Addendum No. 1

April 2, 2025

**City Project No.: 23-067, Package 2
Roads Program Capital Improvement Project**

Delete sheets DM-3, L-1, L-3, CD-7, G-3, DU-1, DU-3, UUD-1, UUD-3, and TH-1 and replace with attached sheets DM-3, L-1, L-3, CD-7, G-3, DU-1, DU-3, UUD-1, UUD-3, and TH-1 of this addendum.

Sheet 17
 of 68 Sheets
L-3

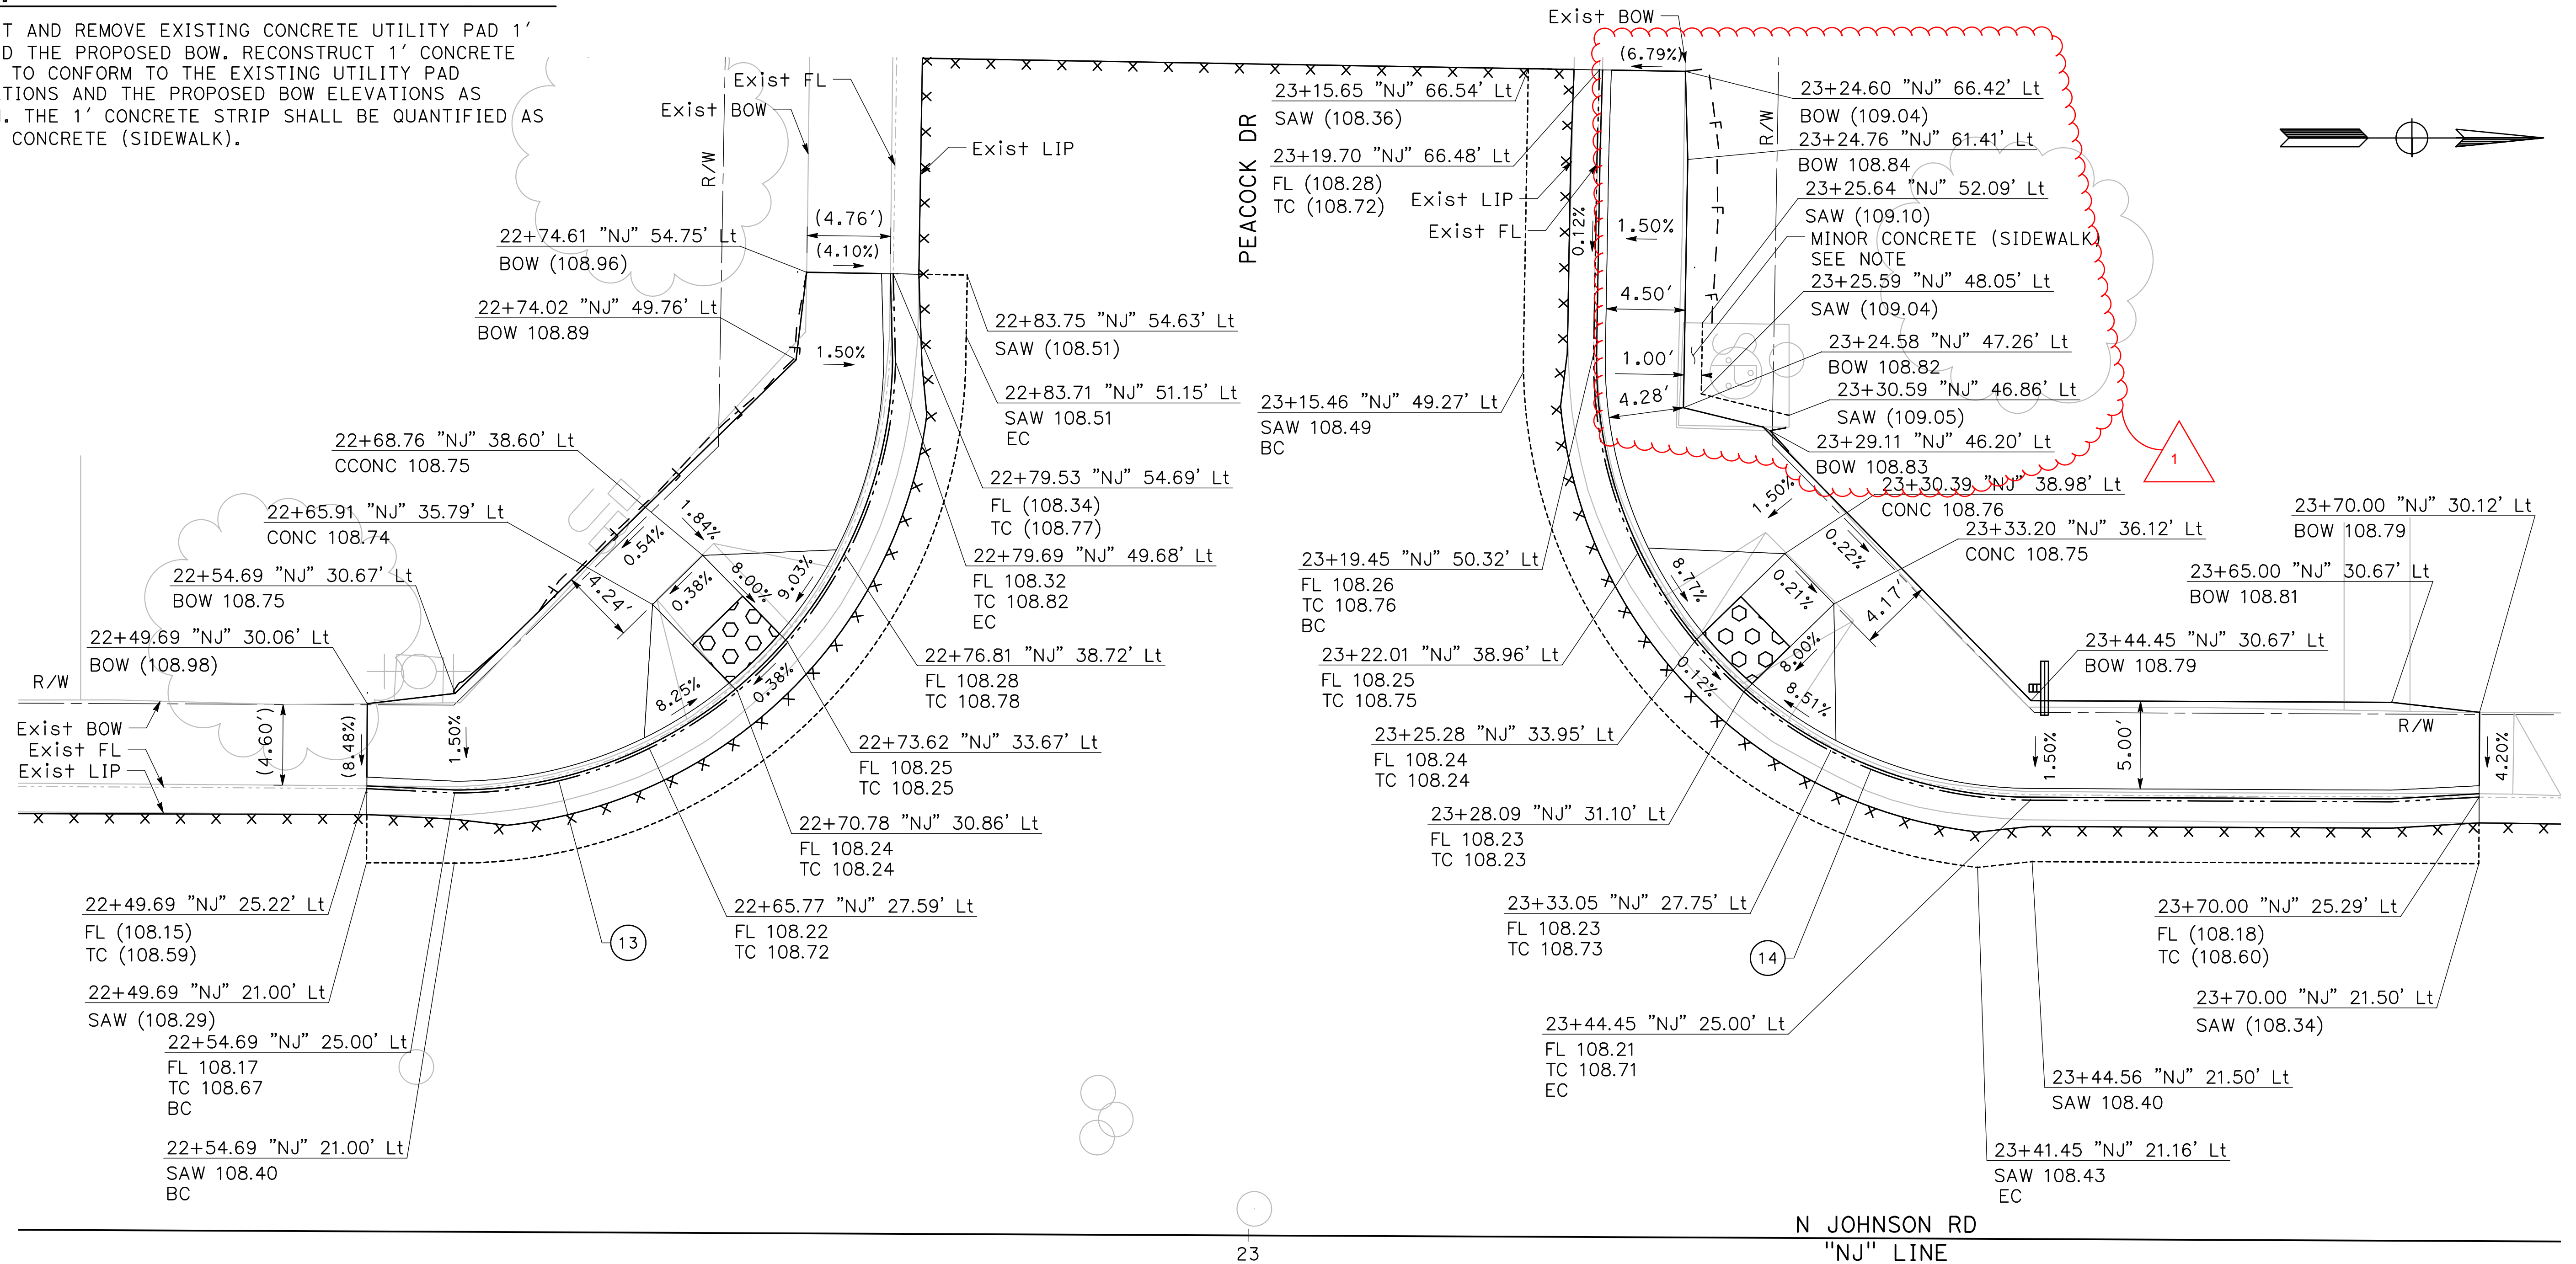
Revisions consist of various items that clarifies callouts, handling of shallow utilities, sidewalk adjustments, and funding sign detail at the intersection of Peacock/N. Johnson.

SAWCUT AND REMOVE EXISTING CONCRETE UTILITY PAD 1' BEYOND THE PROPOSED BOW. RECONSTRUCT 1' CONCRETE STRIP TO CONFORM TO THE EXISTING UTILITY PAD ELEVATIONS AND THE PROPOSED BOW ELEVATIONS AS SHOWN. THE 1' CONCRETE STRIP SHALL BE QUANTIFIED AS MINOR CONCRETE (SIDEWALK).

Sheet **28**
of
68 Sheets
CD-7

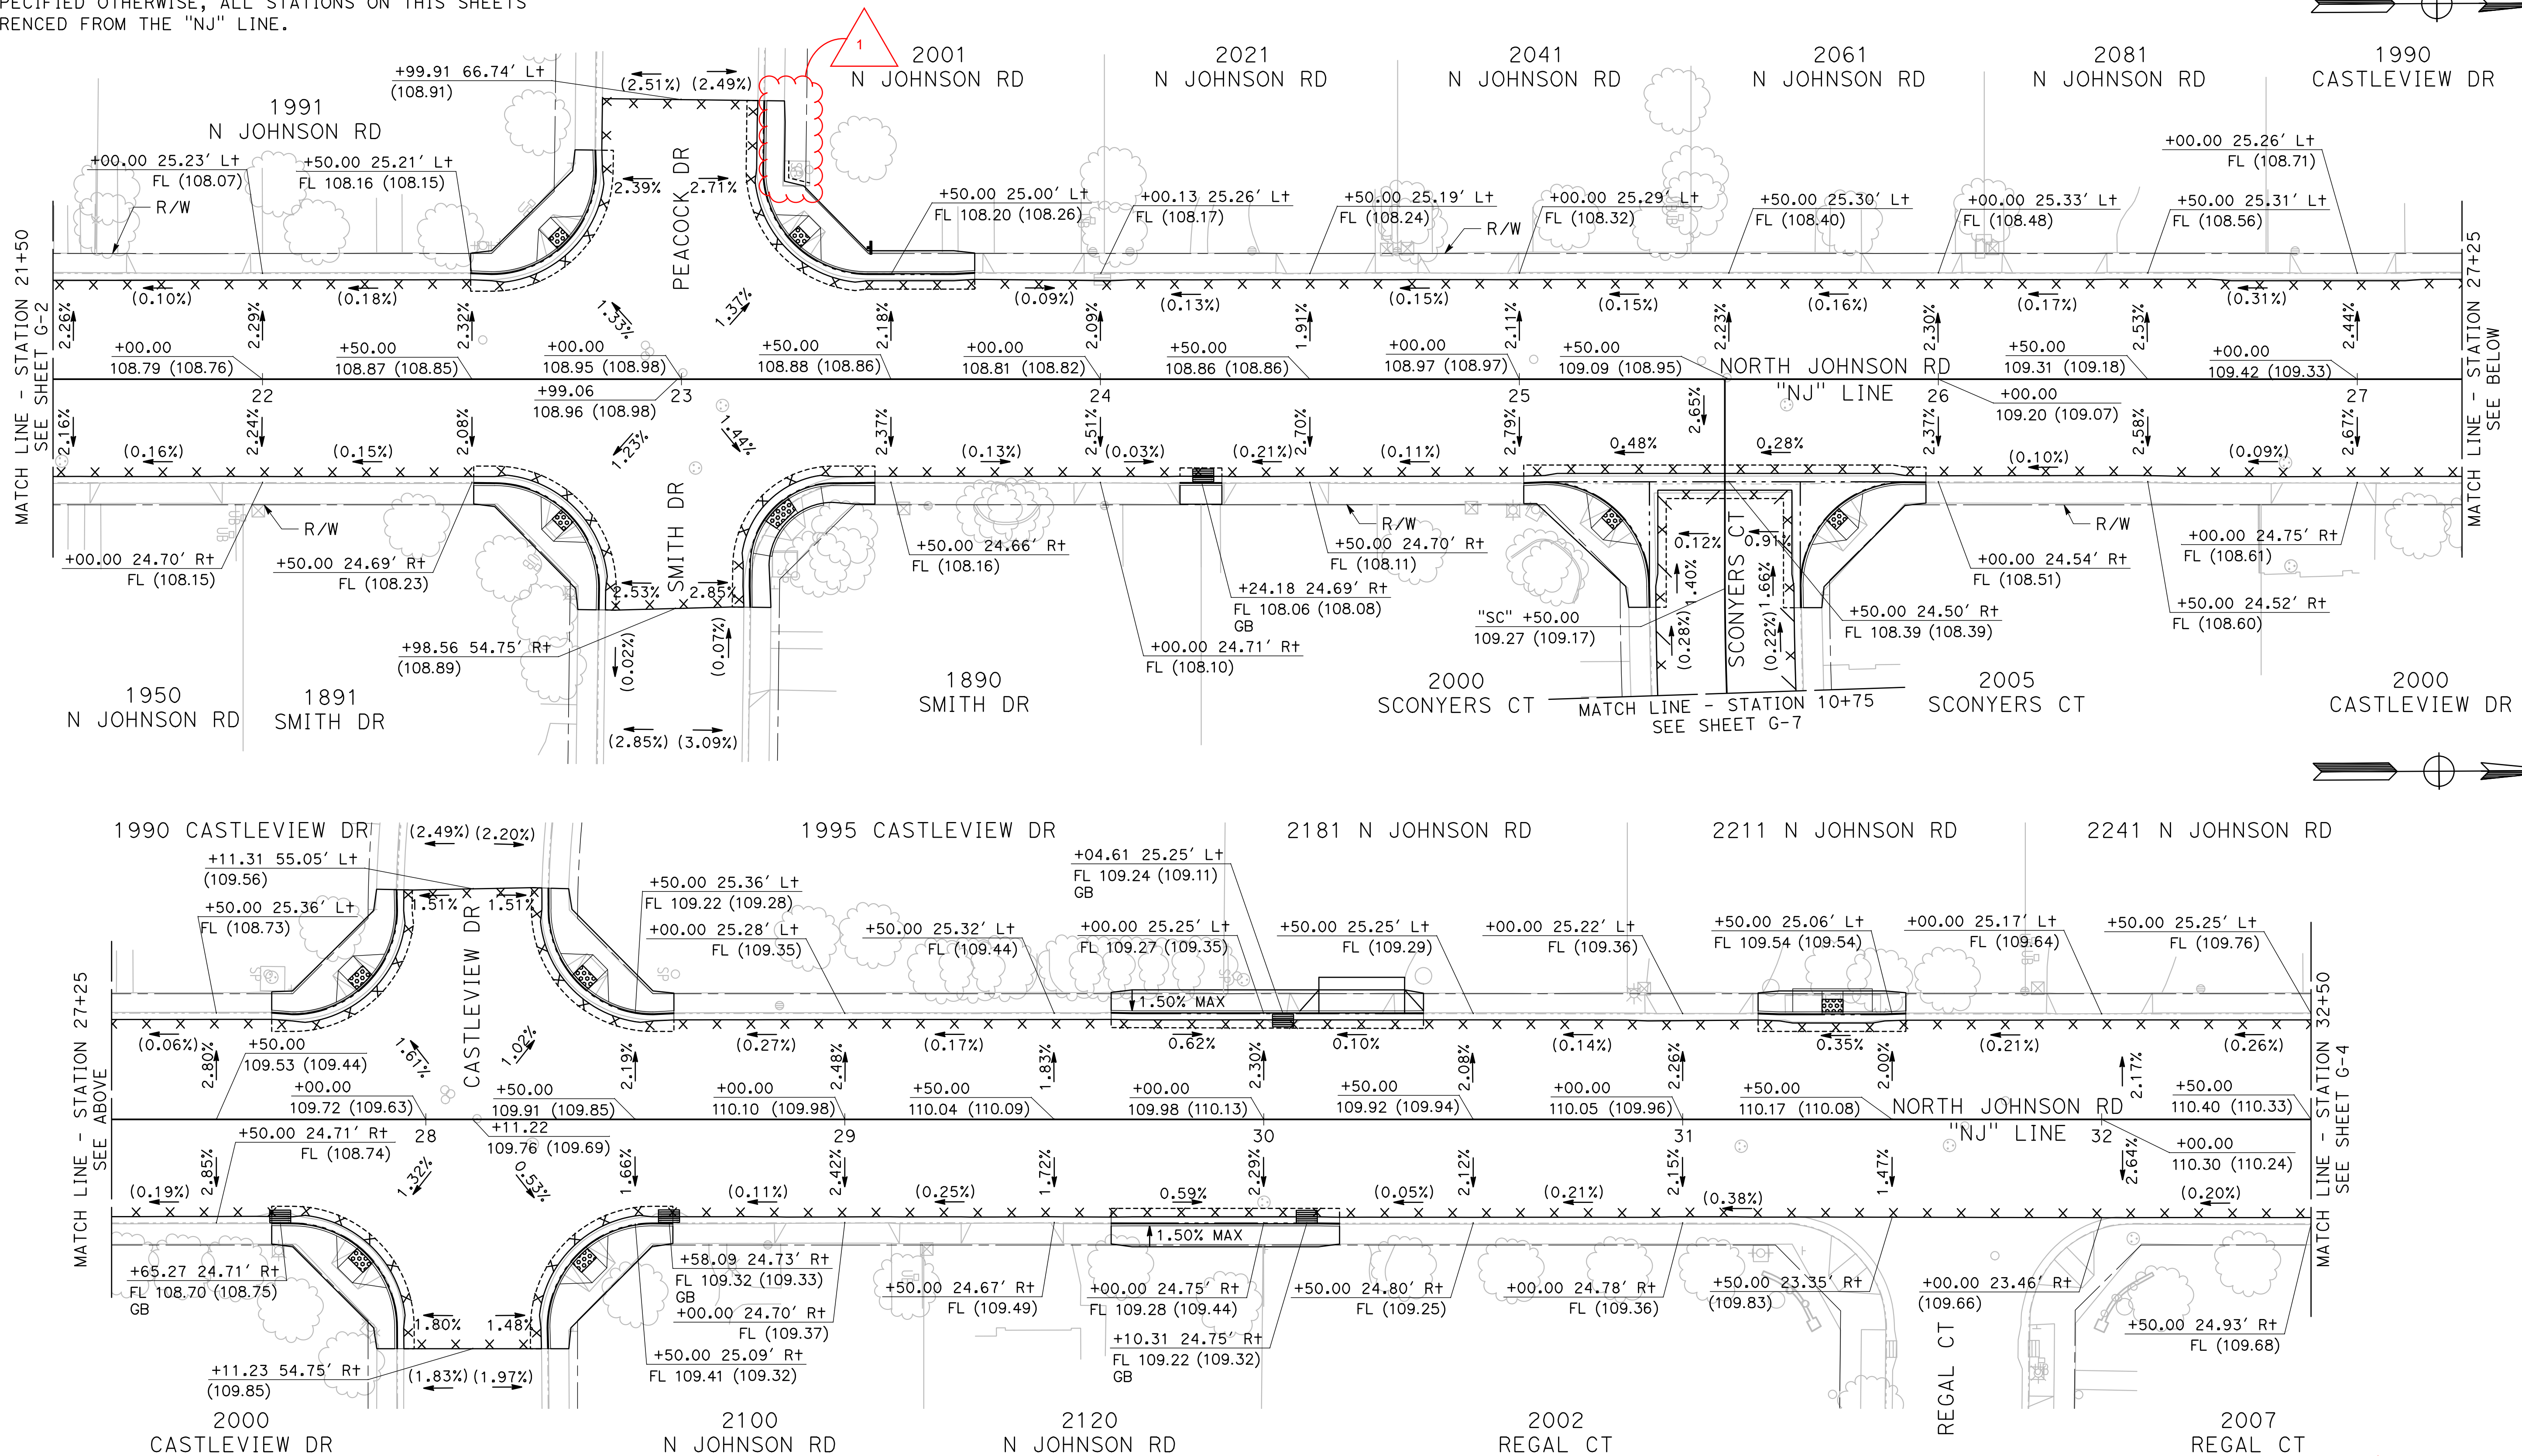
13
CD-7 **N JOHNSON RD & PEACOCK DR**
SW CURB RAMP
SCALE: 1" = 5'

14
CD-7 **N JOHNSON RD & PEACOCK DR**
NW CURB RAMP
SCALE: 1" = 5'

Sheet **51**
 of
68 Sheets
UUD - 1

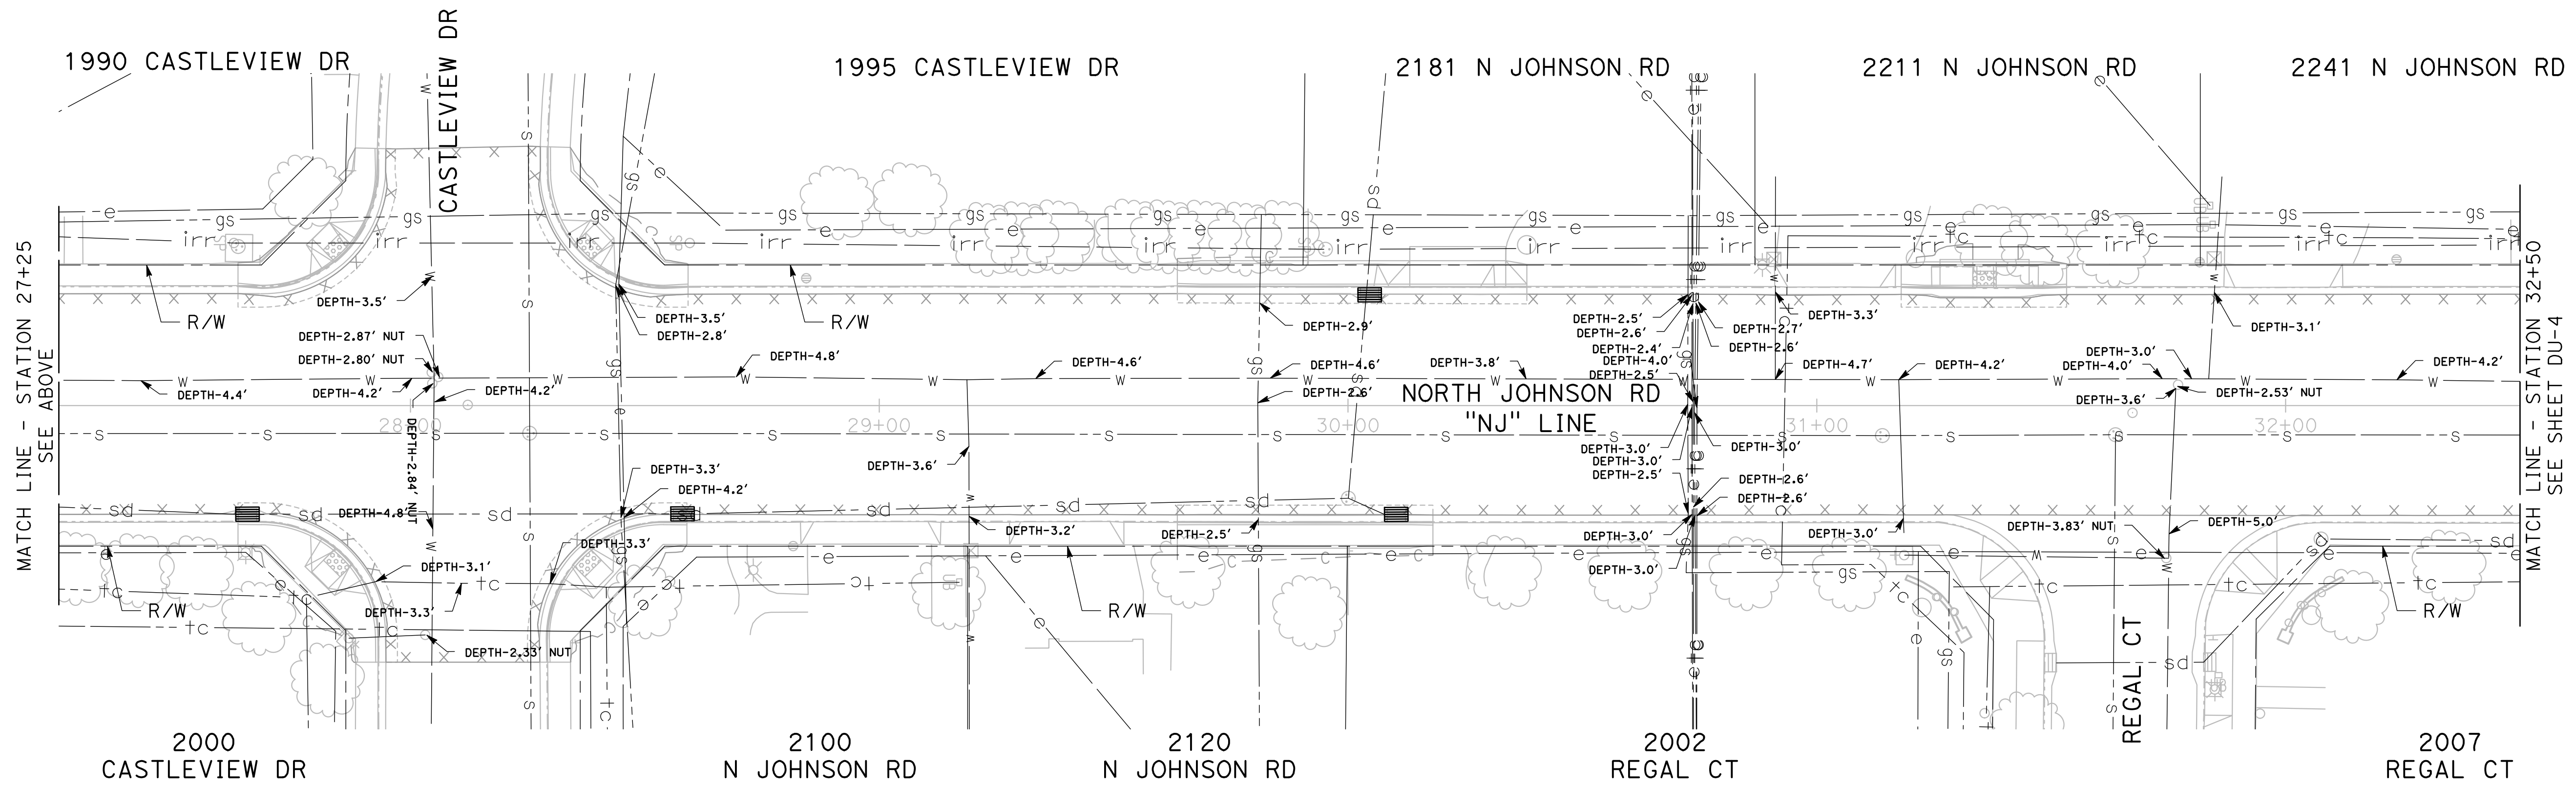
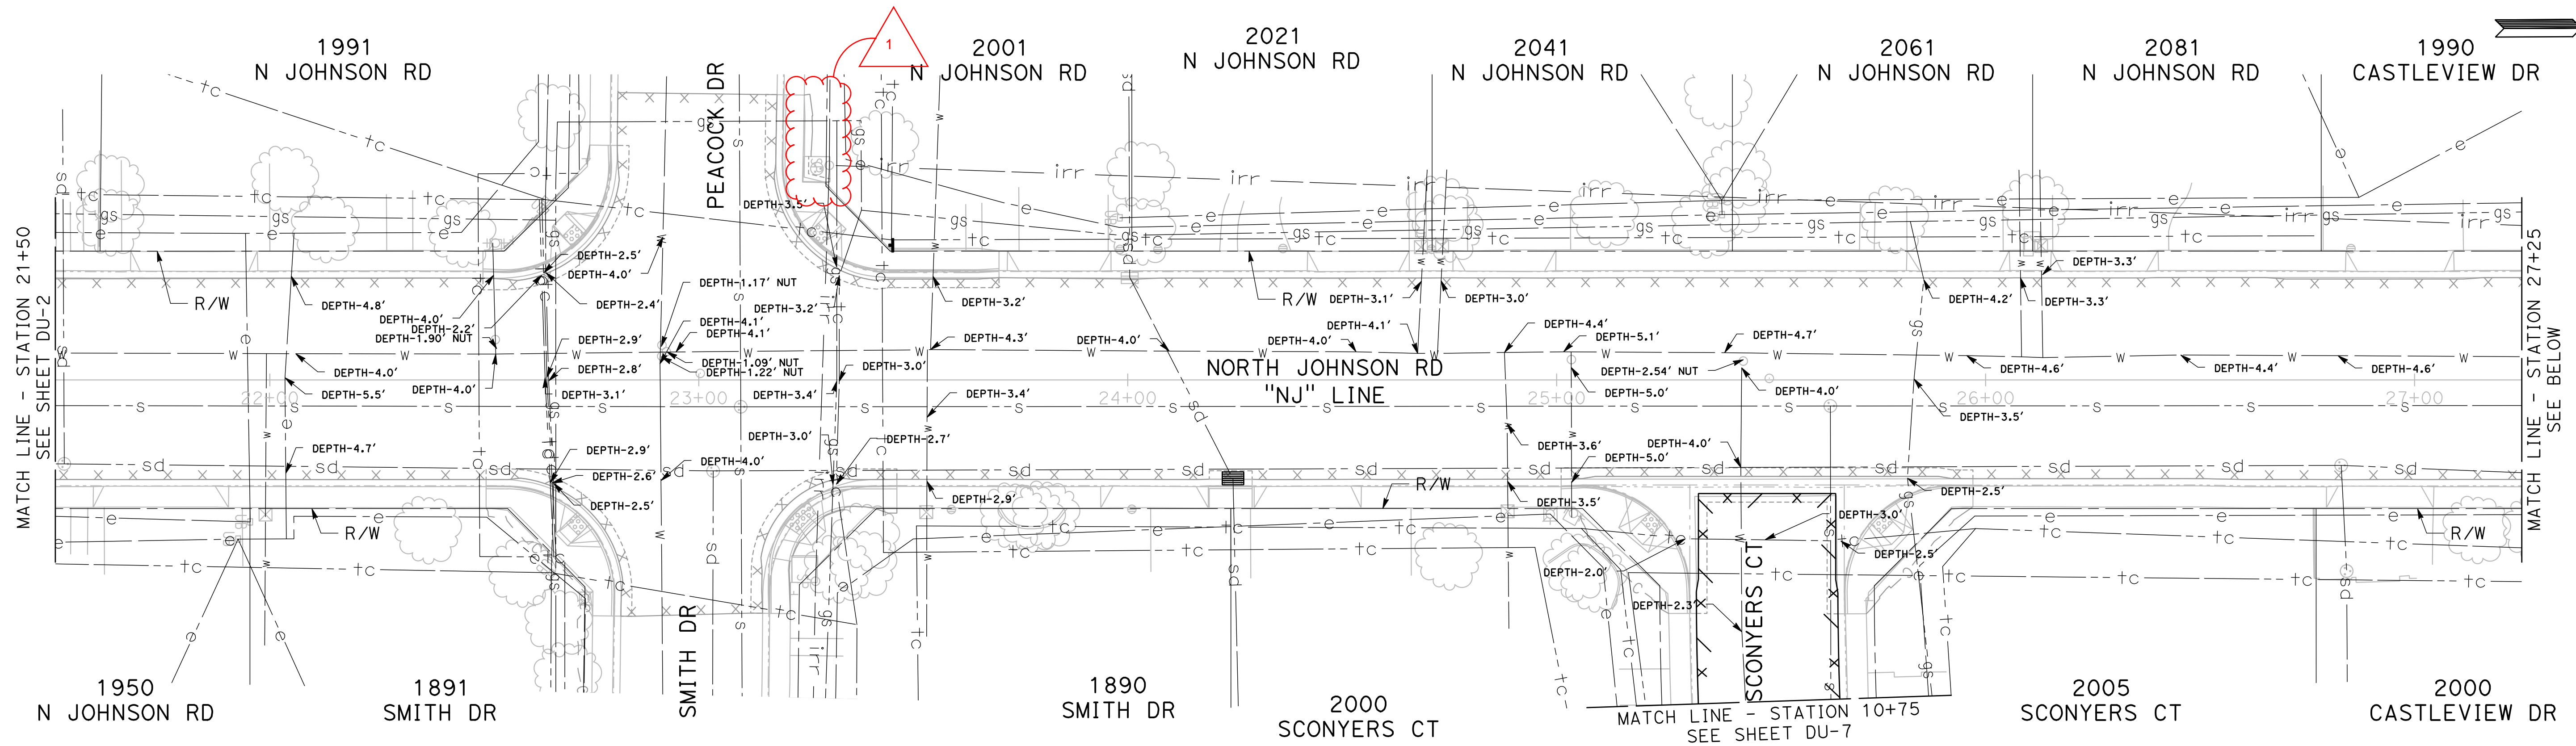
6. FOR PAVEMENT SECTION OVER SHALLOW UTILITIES, SEE DETAIL A ON L-1.
